MARTYN CLARKE ARCHITECTS 78 CROUCH HILL LONDON N6 9EE 0207 263 7121 www.mcarchitects.co.uk		
Project	Aaron & Michele Davies 39 Southwood Avenue London, N6 5SA	Project No. 6276
Date Scale / Format	November 2022 1:50 @ A3	Drawing No. 6276_03_140
Drawing Name Revision	PROPOSED ROOF PLAN A	PLANNING

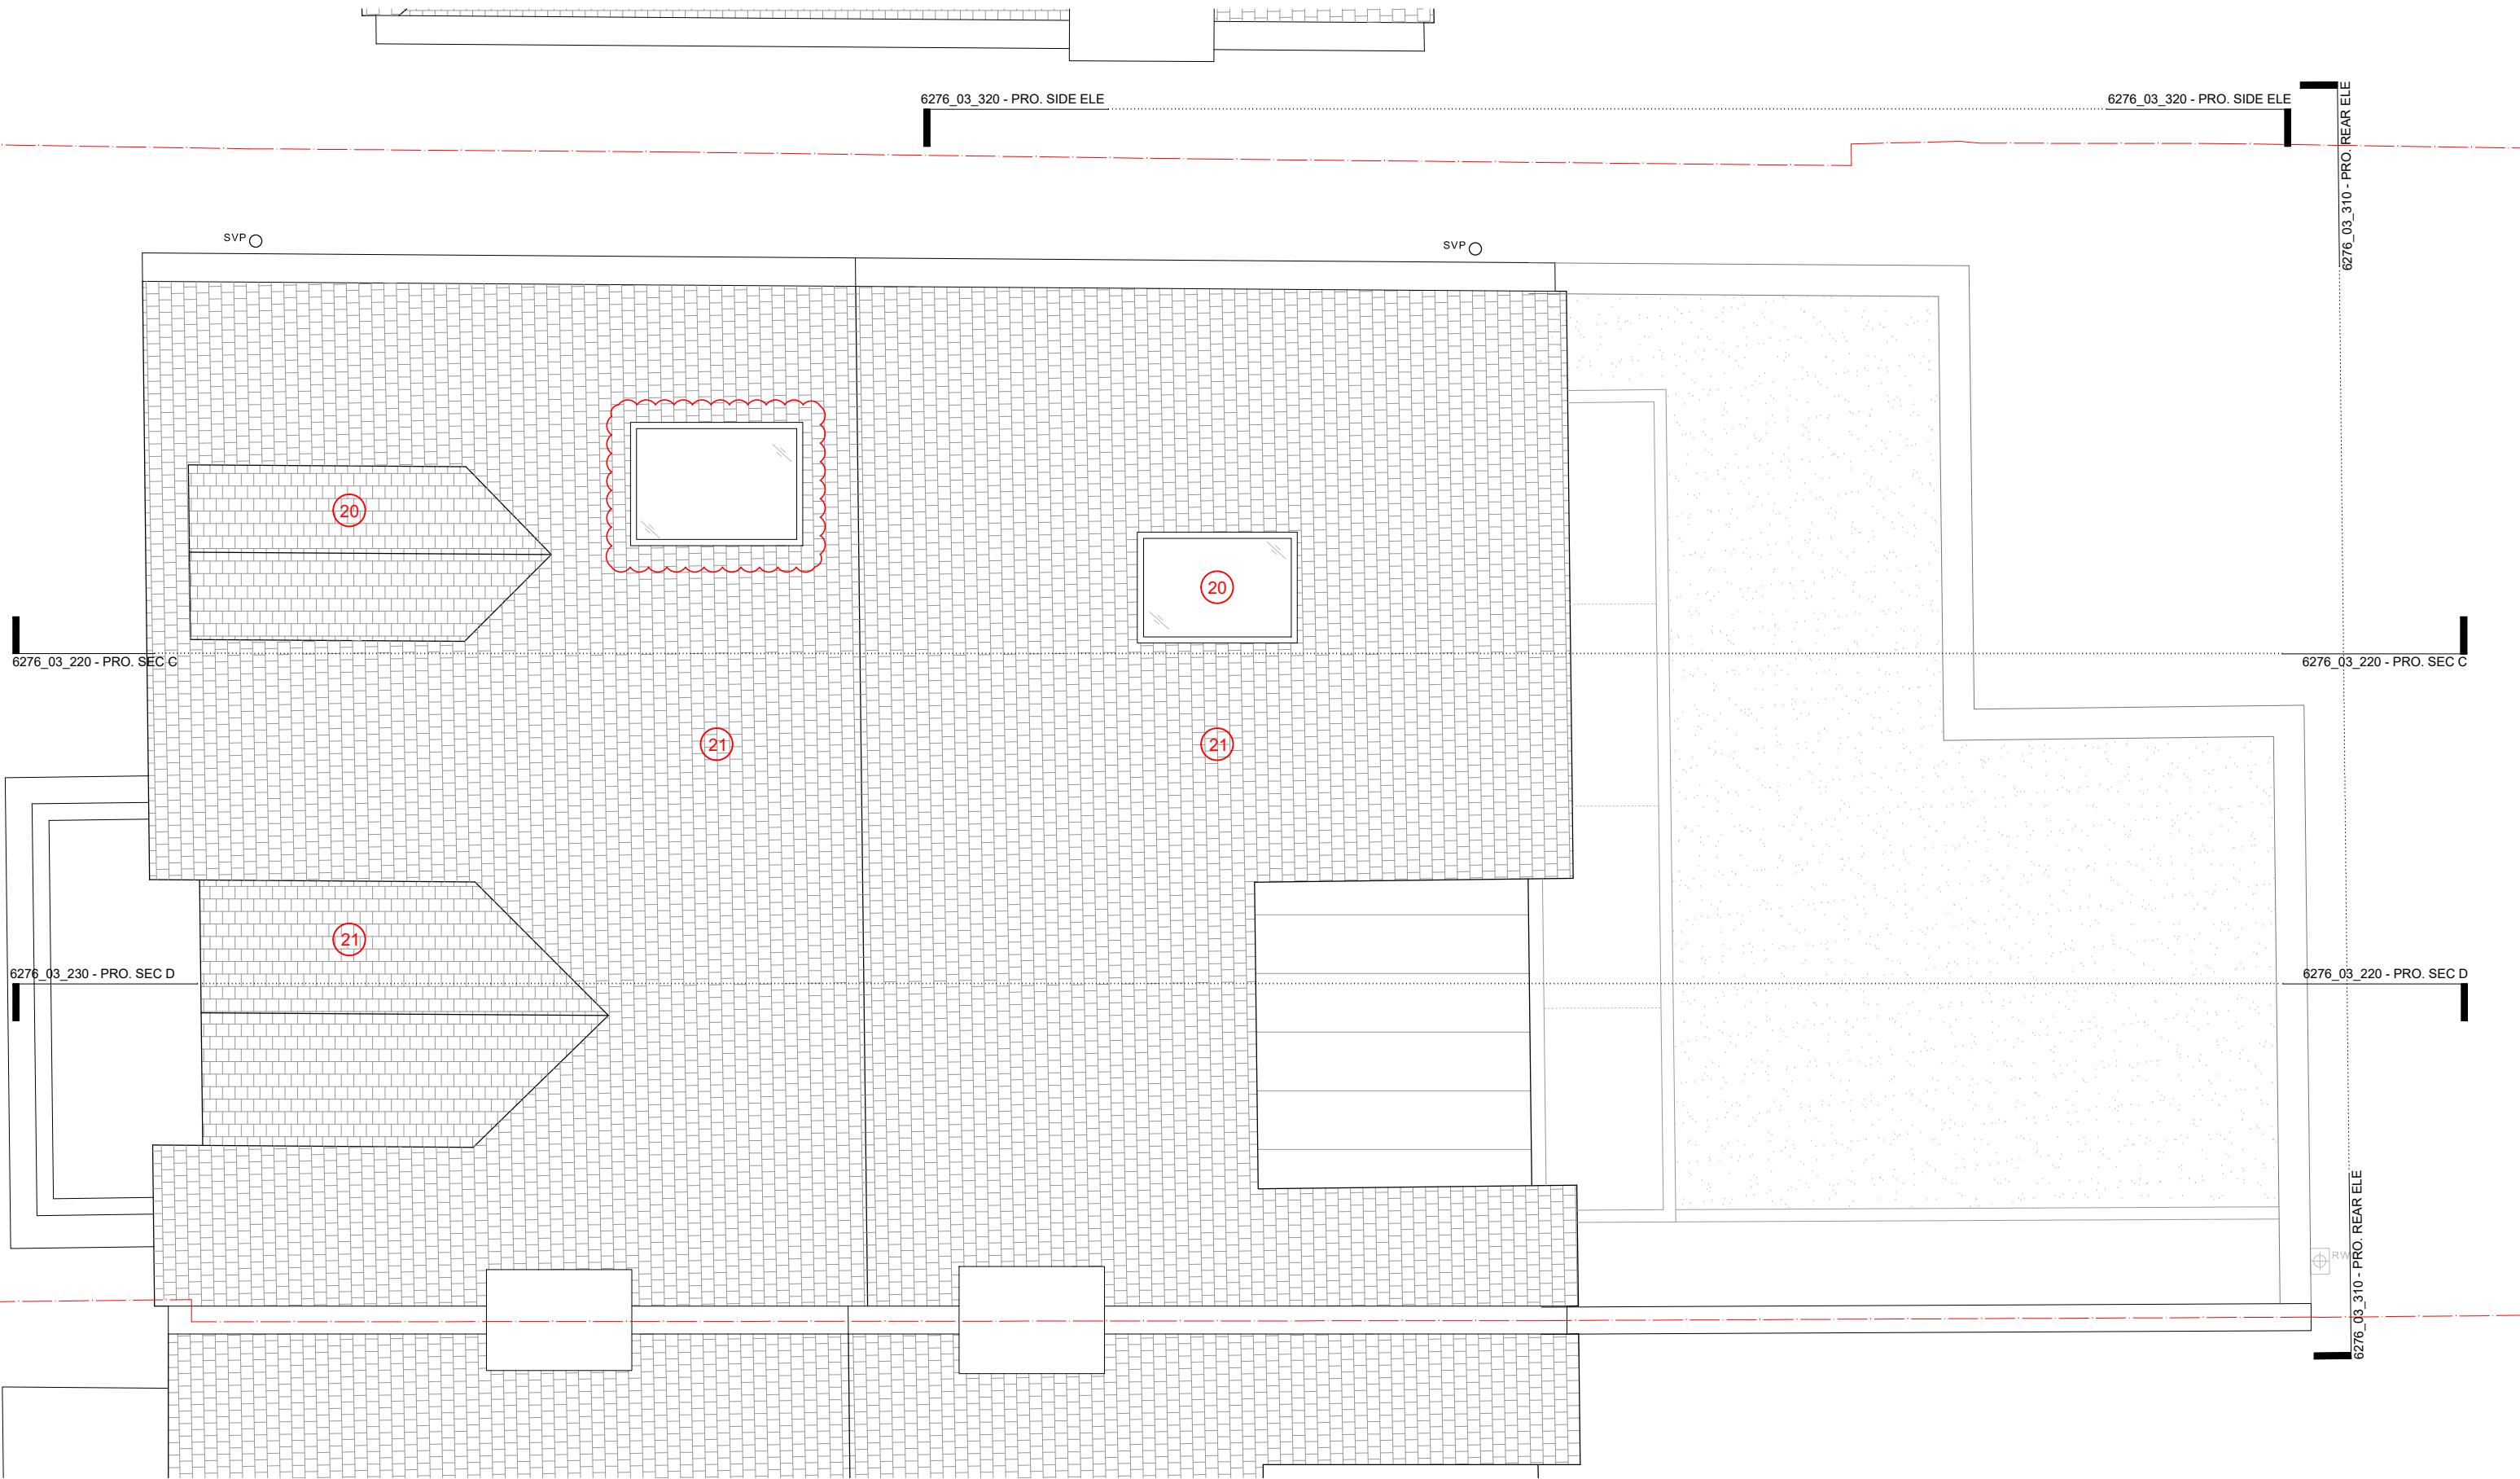
Rev	Date / Info
REV A	19/12/2022 (REVISED AS BUBBLED)
-	ROOFLIGHT TO FRONT ROOF PLANE OMITTED
